Cricklade Town Council

9th March 2026

WC REF PL/2026/00347 – A RESERVED MATTERS APPLICATION BY NEWLAND HOMES LIMITED ON LAND AT STONES FARM, WEST MILL LANE, CRICKLADE

Proposal: Approval of Reserved Matters (Appearance, Landscaping, Layout and Scale) following outline planning permission PL/2022/02452 for 140 dwellings, a habitat support area and associated landscaping.

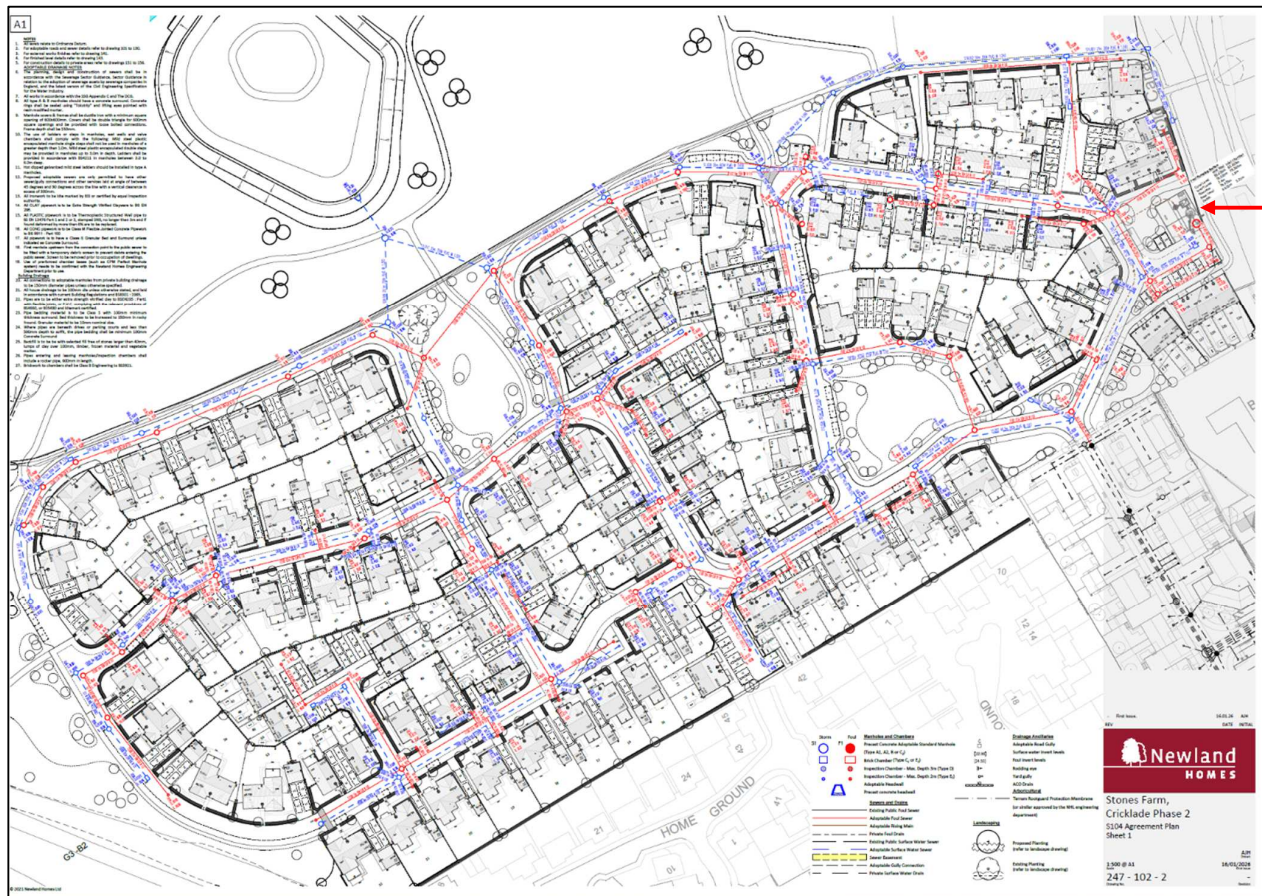
The proposed scheme is essentially the same as that presented in the Outline application. Rainwater from roofs, roads and pavements will drain (marked in blue on the plan below) to an attenuation pond. From there it will be released into the Thames at a rate not exceeding 11 litres per second which is below the current greenfield run off rate.

The WC Drainage Officer supports the application subject to a number of conditions including:

- a) The discharge rate must not exceed 9.4 litres per second (which presumably means that the attenuation pond will need to have a greater capacity)
- b) An Environmental Permit is required from the Environment Agency before discharging into the Thames.

However, the submission of 26th February 2026 from the Environment Agency objects to the application because of the absence of an adequate assessment of flood risk. The submitted flood risk information does not adequately assess whether the development will increase flood risk elsewhere. To overcome this, a Flood Risk Assessment is required that addresses this point.

We agree with this stance, the use of the attenuation pond will hold back the rate of flow of water into the Thames but, over time, the actual volume of water discharged will be greater thereby creating potential problems downstream.

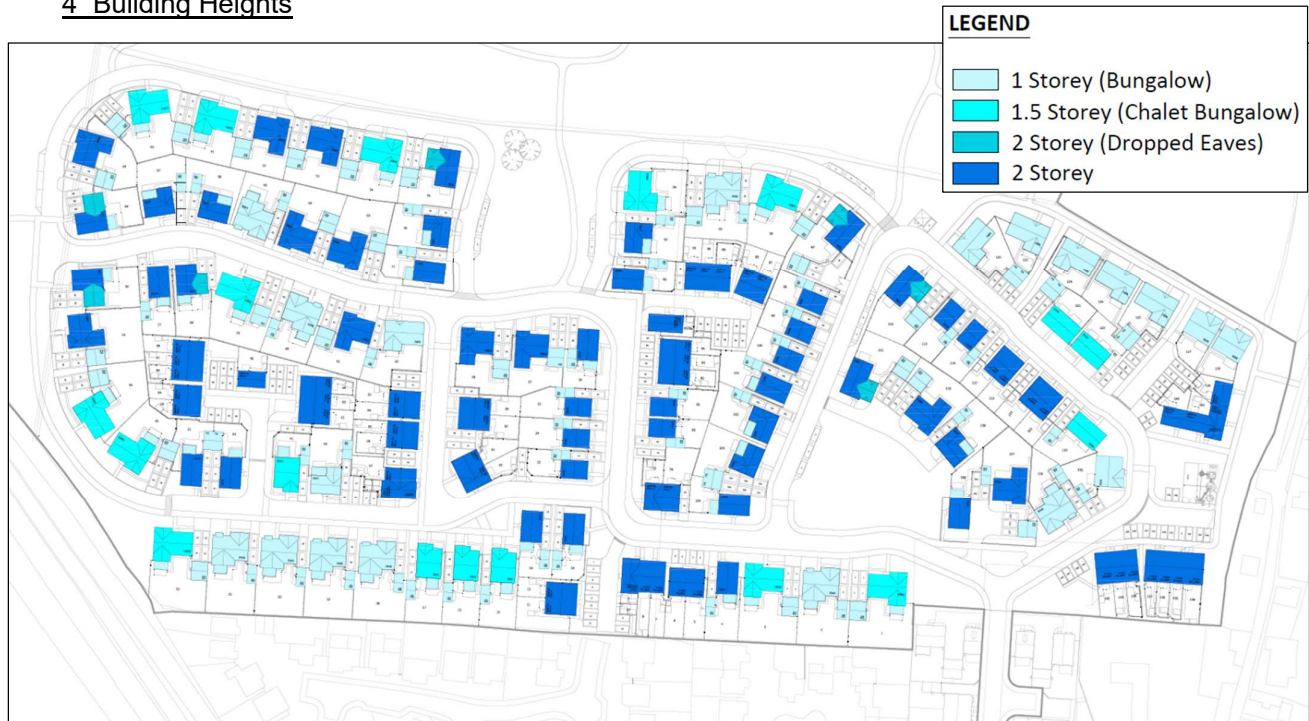
The plans submitted show that foul water will drain (shown in red on the plan below) to a pumping station situated on the eastern boundary of the site. From there it will be pumped to the mains sewer on the Jenners Yard site.

The capacity constraints of the Cricklade Sewage Treatment Works (STW) are well known to residents. In 2024 (the last year for which figures are available) the STW discharged untreated effluent into the Thames on 107 separate occasions totalling 1,378 hours which is the equivalent of over a full day once a week.

Whilst this is welcome news, it is not clear that the 15.4% increase in capacity will be sufficient to cope with the current constraints, let alone the additional throughput from the 140 dwellings of this application. A condition should be placed requiring TW to confirm in writing that, once upgraded, the Cricklade STW can deal with the expected volumes.

Western section
(next to old railway line)

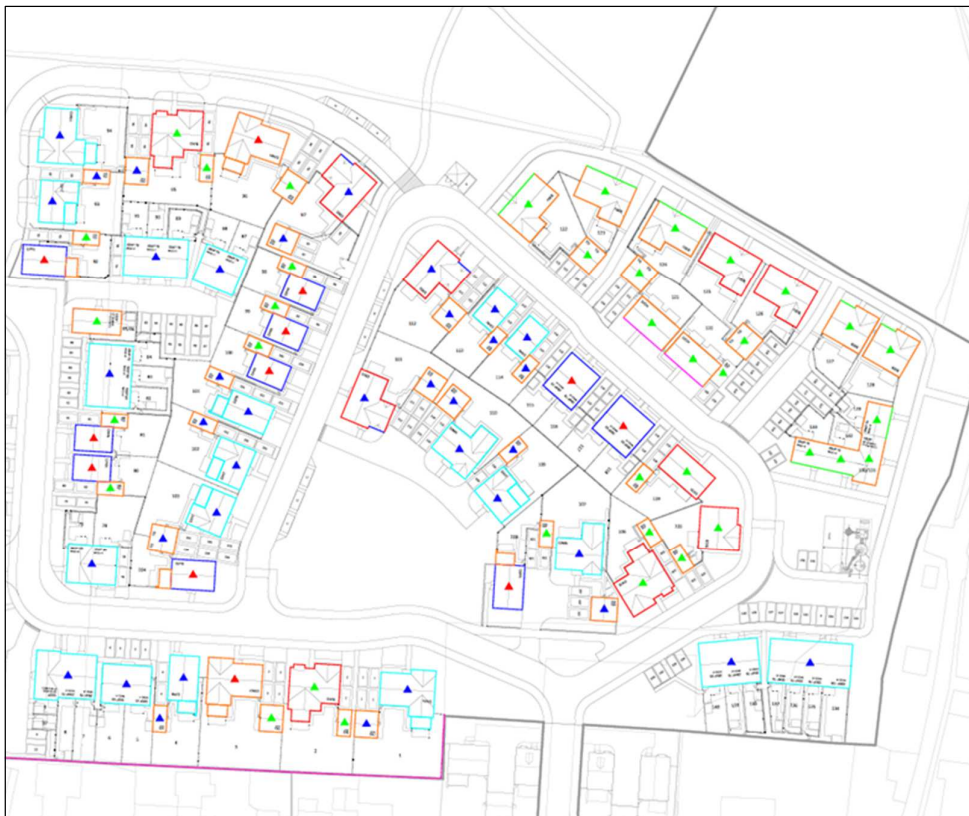
The street scene plans and graphics above show that the applicant is proposing to use a mixture of materials with dwellings built of brick, stone and render for walls. Differing colours for roofs are shown and a wide variety of building designs. The housing consultation carried out as part of the current Cricklade Neighbourhood Plan showed that residents were of the view that Stockham Close – which has a mixture of building materials - was the most highly regarded of the recent housing developments in the town with 61 'likes' compared to 40 for the next.

The most noticeable feature is a preponderance of red roofs because those described as 'plain' are also red, albeit muted, which could make the solar panels stand out even more. In the Design Statement the applicant displays 18 photographs of housing scenes in the town and the only ones that are red are on the adjoining Jenner Close. In view of the visual impact of the development towards North Meadow and the Thames Path National Trail it is suggested that more traditional grey slate approach be used.

- c) In view of the visual sensitivity of the site from North Meadow and the Thames Path National Trail, the preponderance of red roofs should be significantly reduced and replaced with grey slate to more properly reflect the local vernacular.

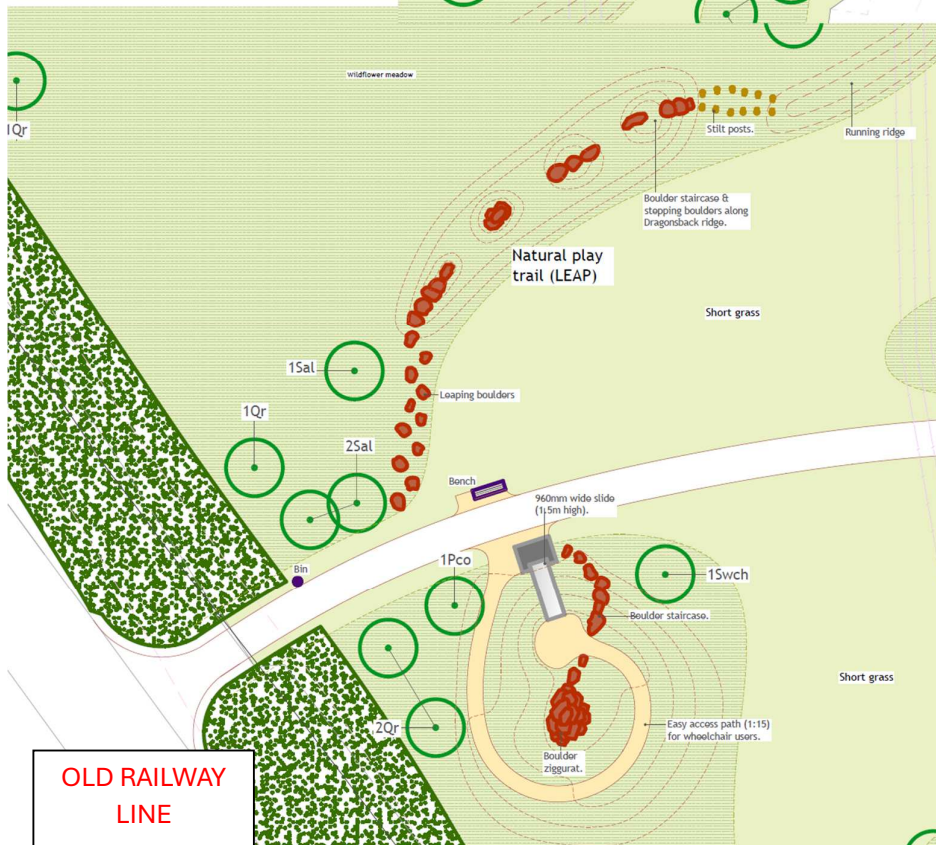
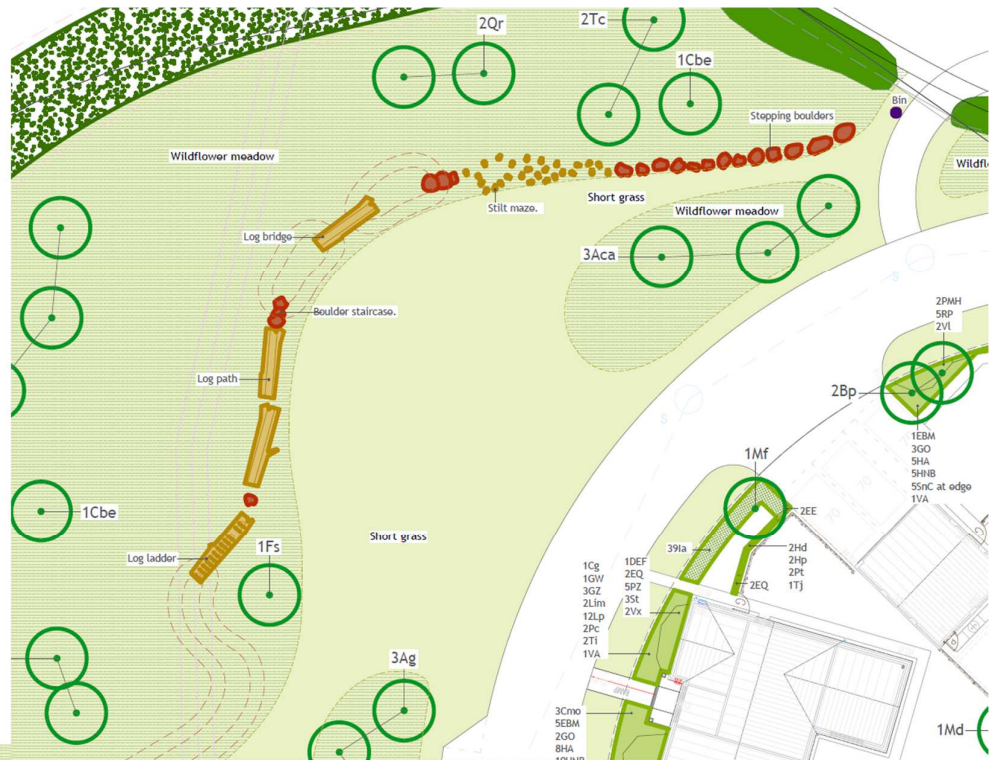
WC Core Policy 43 requires "Affordable housing units will be dispersed throughout a development and designed to a high quality, so as to be indistinguishable from other development. In determining the level of integration that can be achieved, consideration will be given to the practicalities of management and maintenance associated with the proposal whilst still ensuring affordability, particularly in developments of flats."

It is not clear that the proposed layout meets these requirements - although we note the somewhat contradictory comments of the WC Projects and Enabling Officer that "Plots 35 and 36 appear to pair Affordable Rent and Shared Ownership in a semi-detached arrangement. To support effective marketing, we generally ask that different affordable tenures are not attached to one another. Ideally, each affordable tenure type should sit within its own small cluster to ensure clarity for residents, registered providers, and prospective purchasers."

We are the opinion that the location of the affordable houses is suitable.

CRIC34 Bridleway shown in blue:

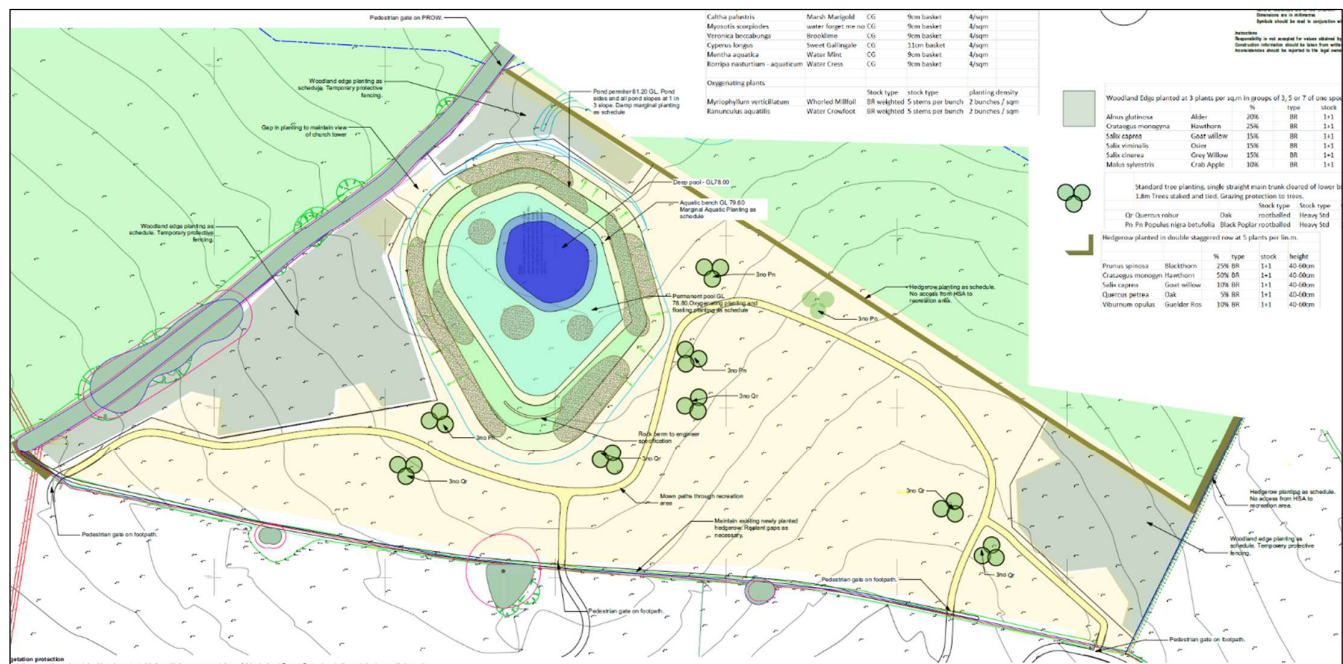
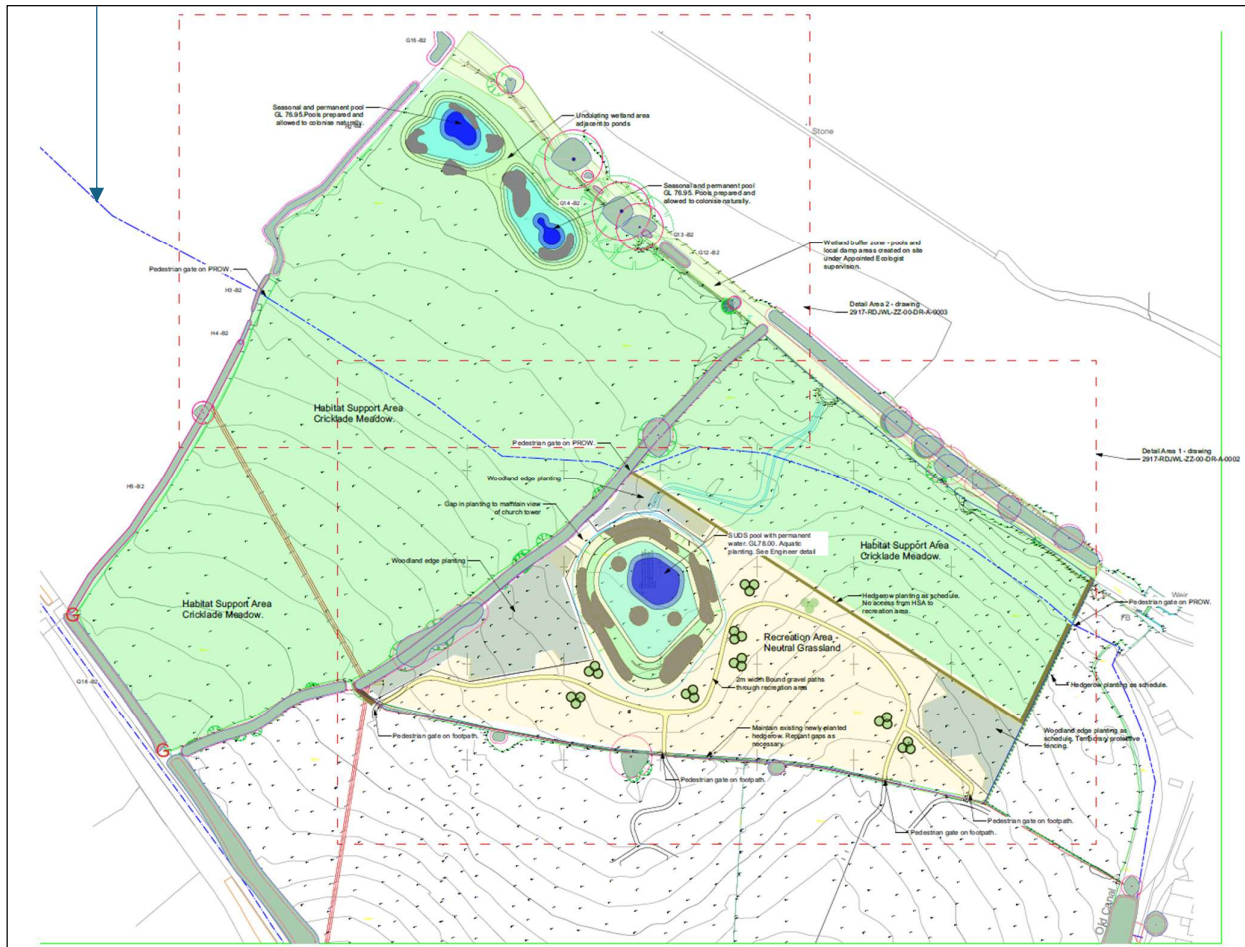
The Recreational HSA will be neutral grassland with mown footpaths to aid accessibility and with woodland edge planting to the east and west boundaries – shown in the darker green. The attenuation pond is designed to have water in at all times. We are of the opinion that the paths should be hoggins to ensure year round use otherwise they will just become muddy in wet conditions.

The Biodiversity HSA will be sown with 'Cricklade' wildflower meadow mix and have a wetland area at the northern tip. It is crossed by the existing bridlepath CRIC34 which follows the route of the old canal and is shown in blue on the plan.

Unfortunately the plans submitted with this Reserved Matters application show that direct access from the Recreation HSA (yellow) to the Biodiversity HSA (green) will not be possible, the linking paths shown on earlier plans have all been removed. The plan above showing the new hedge to be planted to demarcate the boundary between the Recreation and Biodiversity HSA areas to the north east explicitly states that "no access from HSA to recreation area." Whilst access to the bridleway CRIC34 is possible from West Mill Lane, the path beside the old canal is not level, very muddy in wet weather and goes through the yard at West Mill Farm (see schedule of photos below).

The plans for the HSA must be revised to:

- 1) Reinstate the linking paths from the Recreational HSA north east and north west to the Biodiversity HSA that were shown in previous versions of the plans,
- 2) Create a mown path around the whole of the Biodiversity HSA which will produce a circular walk of 1.5km including of 400m of riverbank,
- 3) Convert at least one of the two five-bar gates that open on to the old railway line to allow pedestrian & cycle access thereby enabling more circular walks to be created. (This is in addition to the access point from the residential area that will be created).
